## DISCRETIONARY REVIEW ABBREVIATED ANALYSIS

**Record No.:** 2019-017673DRP  
**Project Address:** 46 Racine Lane  
**Permit Applications:** 2019.0923.2311  
**Zoning:** RH-1 [Residential House, One-Family]  
40-X Height and Bulk District  
**Block/Lot:** 5067 / 011B  
**Project Sponsor:** Xie Guan  
26 Fairview Court  
San Francisco, CA 94131  
**Staff Contact:** David Winslow – (628) 652-7335  
[david.winslow@sfgov.org](mailto:david.winslow@sfgov.org)

**Recommendation:** Do Not Take DR and Approve

Picture 3: View from Bayshore Blvd of neighboring houses with three stories consistent with proposed design.

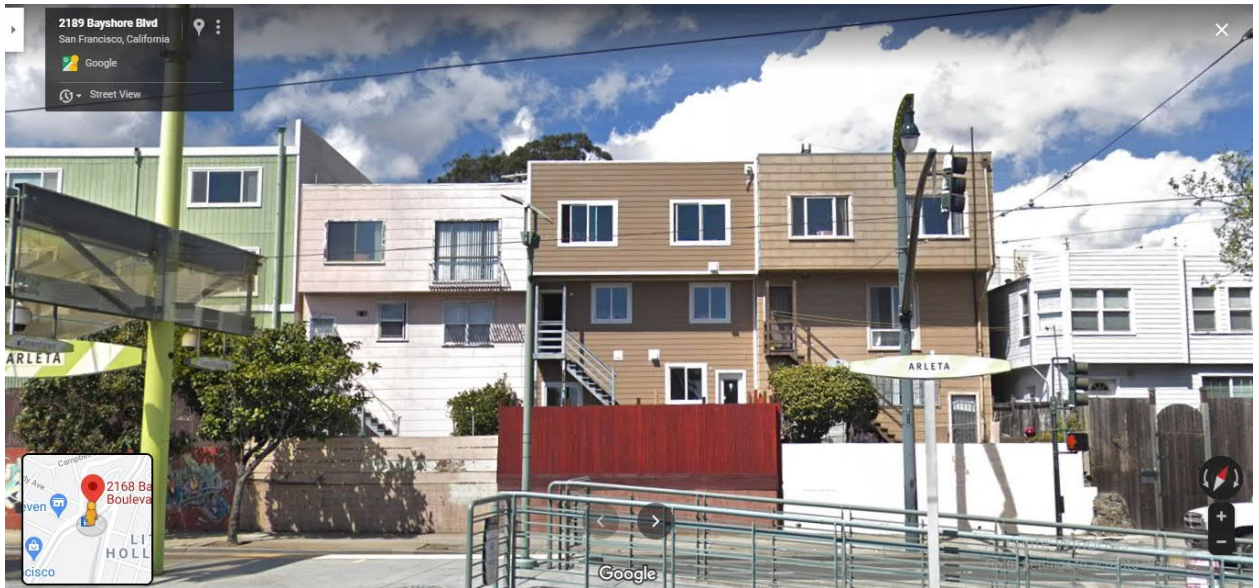
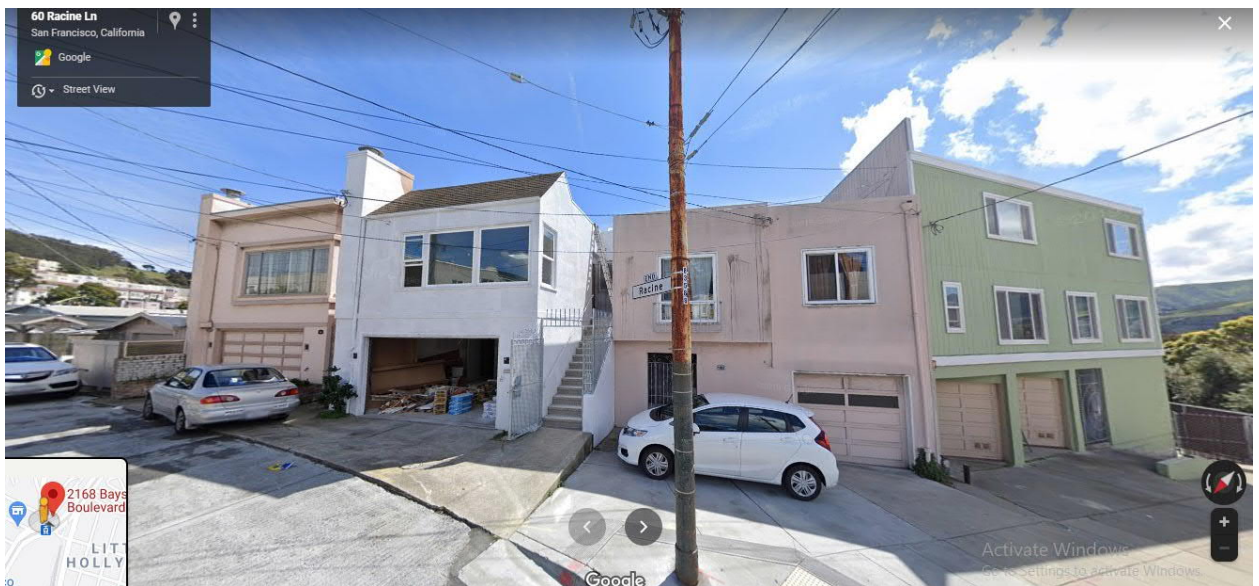
2. Requester concern: "...all houses are 2 story-level buildings..."

Clarification: Proposed project is a two story building on Racine Lane side. Project have an elevation difference of ~15 feet between Racine Lane and Bayshore Blvd, hence the basement on Bayshore side. Height and design is consistent with neighboring house address 4115 San Bruno, 4111 San Bruno, 60 Racine and 58 Racine. Please refer to pictures 3 and 4 below.

Furthermore, overall project height on Bayshore is also similar to adjacent house address 2158. To reduce height and bulk of the top story from the Bayshore side, project is set back ~13 feet from the front of the building in addition to the ~17 feet set back from the street. Height limit and top floor setback are City design requirements that proposed design met.

Picture 4: View from Racine Lane of neighboring houses with two stories consistent with proposed design.

Picture 5: Snippet from Assessor BLK 5066A/5067. Highlighted dimensions are width of lots with side setbacks. All lots with side setbacks exceed standard 25 feet wide.

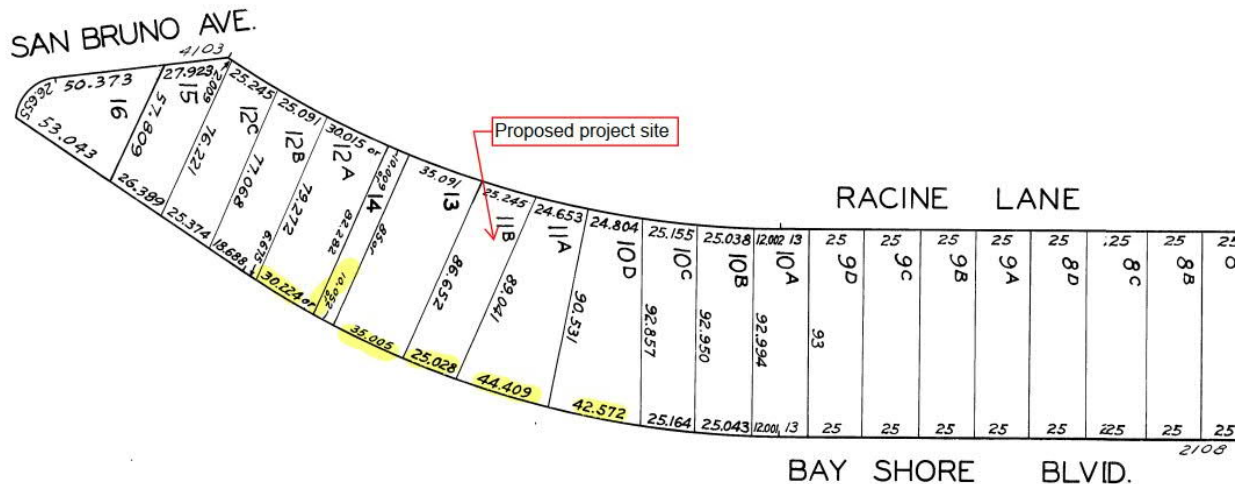
3. Requester concern: ...most importantly side spacing of around 3 ft. between buildings...

Clarification: All houses specified by Requester with side setbacks have lot sizes exceeding standard 25 feet wide. Please refer to picture 5 below of a snippet from

Assessors BLK 5066A/5067. House address 2174 Bayshore (lot 12A) is ~30 feet wide plus sharing 10 feet from lot 14, 2168 (lot 13) is ~35 feet wide plus sharing 10 feet from lot 14, 2158 (lot 11A) is ~44 feet wide and 2152 (lot 10D) is 43 feet wide. There are no houses on the block with 25 feet wide lots have side setbacks. Furthermore, throughout the whole City, 25 feet wide lots with side setbacks may be non-existent. It is absurd to expect proposed project to have a side setback.
